**RESOLUTION HOLDING PUBLIC HEARING ON APPEAL BY
EYCHANER PROPERTIES, INC. OF THE DENIAL OF A SITE PLAN
AMENDMENT FOR A PROPOSED VALET DROP-OFF LANE AT
322 SOUTHWEST 3RD STREET**

Communication from the City Plan and Zoning Commission advising that at their meeting held October 16, 2014, the following action was taken regarding a request from Eychaner Properties, Inc. (owner) represented by Rich Eychaner for an appeal of an administratively reviewed Site Plan which has been denied based on the design guidelines within the "D-O" Downtown Overlay District on property located at 322 Southwest 3rd Street.

300 MLK - GEOMETRIC PLAN

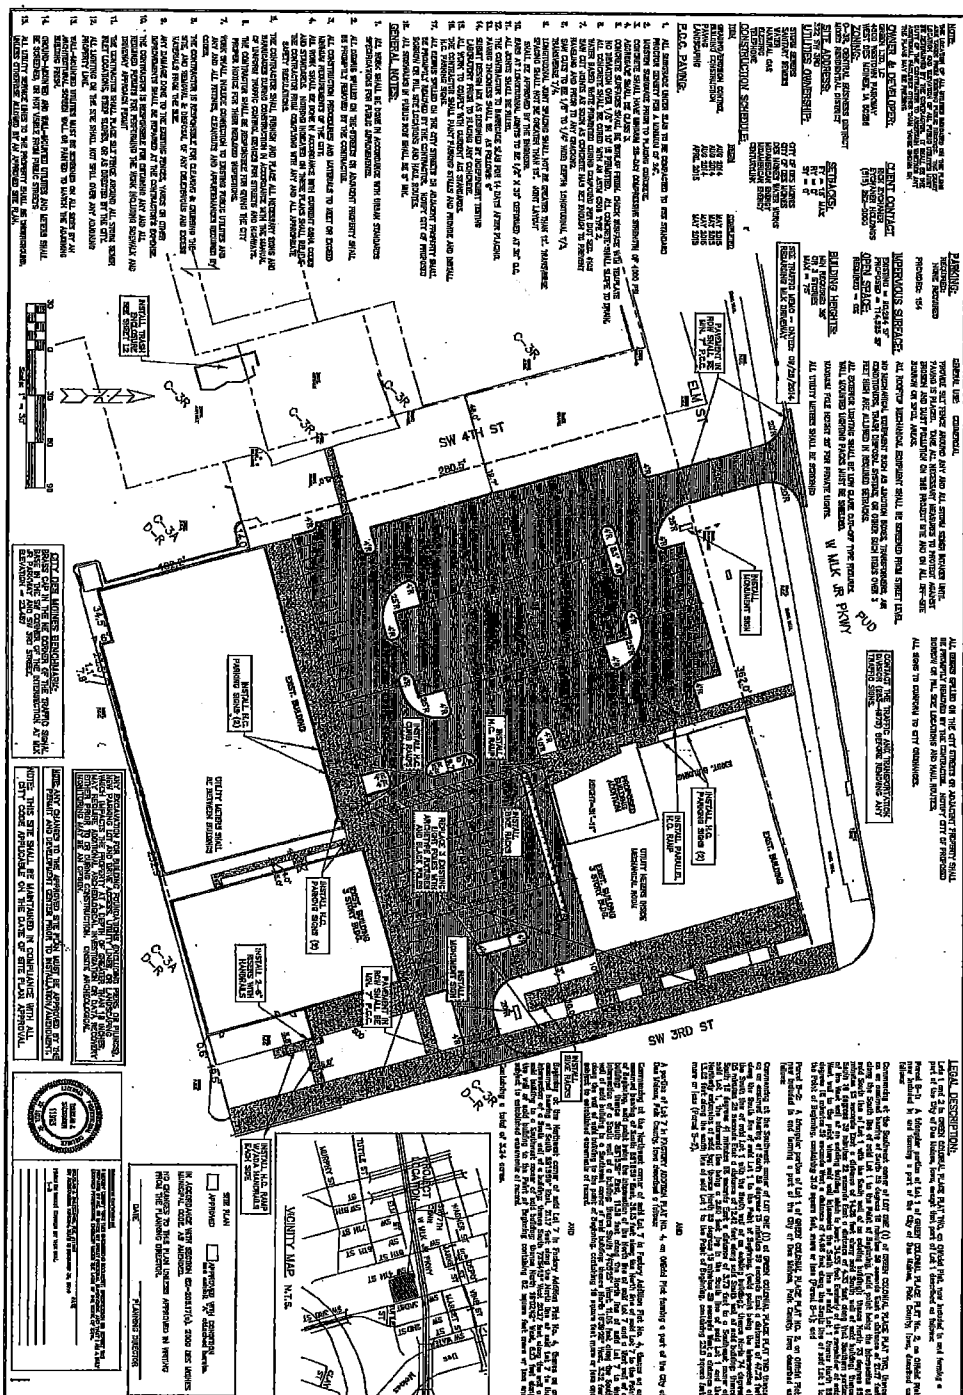
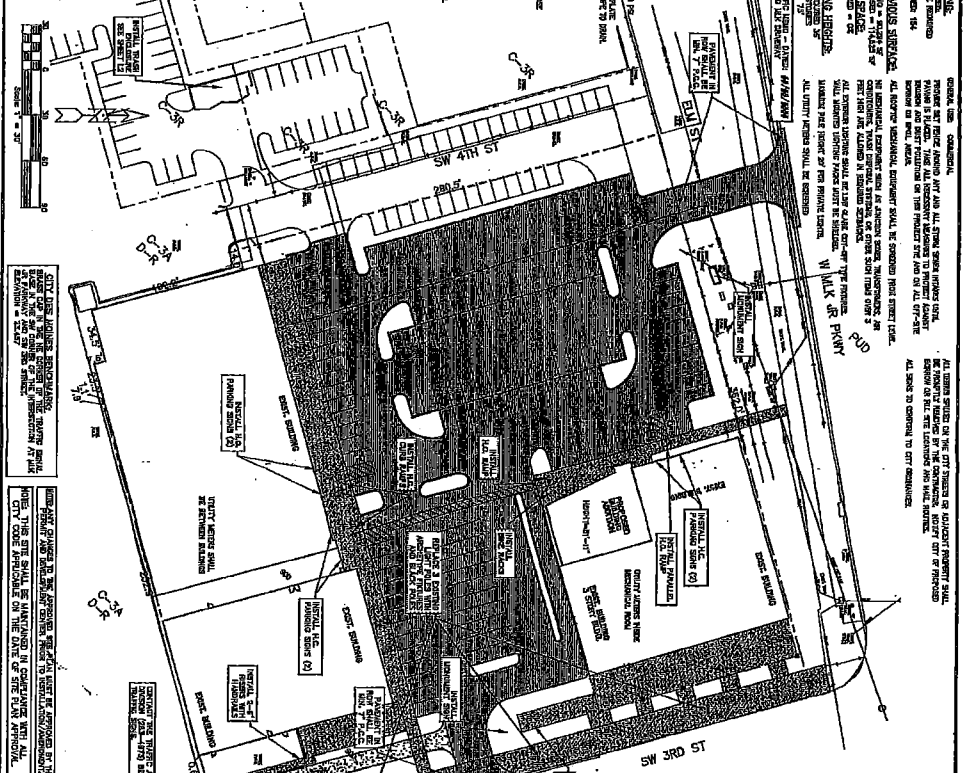
The buildings are setback from SW 3rd Street. The applicant is proposing patio and plantings in this area. The proposed drop-off lane would reduce the amount of onsite green space.

West Martin Luther King, Jr. Parkway and SW 3rd Street are Designated Pedestrian Corridors. The proposed development does not comply with this criterion. The site does not have access to a side street to the south. Therefore, flexibility has been given in the introduction of a driveway and parking lot frontage along SW 3rd Street and West Martin Luther King, Jr. Parkway. In addition, staff compromised on allowing a drive-thru facility on the south side of the northern building so long as the drive-thru and parking lot did not extend past the east wall plane of the building. Landscaping, an ornamental fence and a bike parking area are proposed to obscure views of the drive-thru and parking lot from SW 3rd Street. Landscaping and an ornamental fence are proposed along the north perimeter of the parking lot facing West Martin Luther King, Jr. Parkway.

Staff does not support the addition of the proposed drop-off lane as it is contrary to the purpose of establishing pedestrian oriented routes within the downtown. The impact of adding the proposed drop off lane must be viewed in context with the other auto-oriented features that staff has already approved. A reasonable alternative is to develop a valet drop-off area within the parking lot to the north of the subject building. The additional parking spaces that were added to the Site Plan by allowing the trash enclosure to be developed offsite would offset the potential loss of parking. Tenant turnover could greatly alter the scope and magnitude of the lane's use in the future. A designated drop-off lane within the parking lot could be easily converted to parking spaces should tenant change occur.

Staff believes that a single curb cut to West Martin Luther King, Jr. Parkway and a single cut to SW 3rd Street are the minimum number necessary to support the development. The proposed drop-off lane would add a second curb cut to SW 3rd Street.

Dann Flaherty moved staff recommendation Deny the request for a valet drop-off lane along SW 3rd Street.

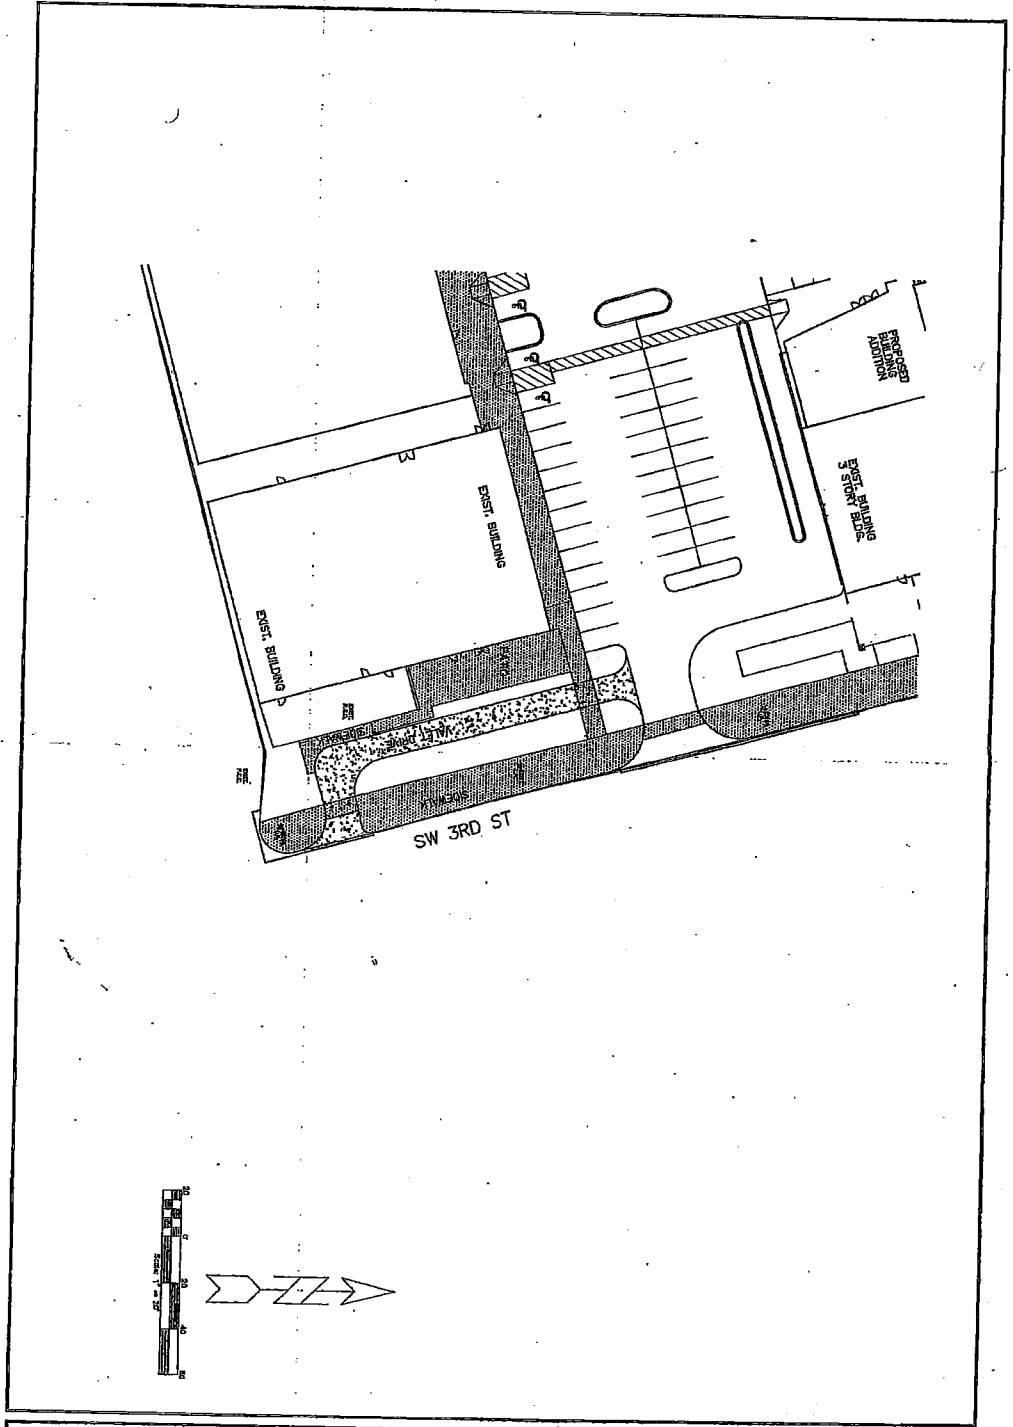
We (Ballyard Lofts) don't have an issue with your drop-off lane either, but would ask that vehicles be promptly moved after clubs are dropped off to avoid potential back up onto 3rd Street.
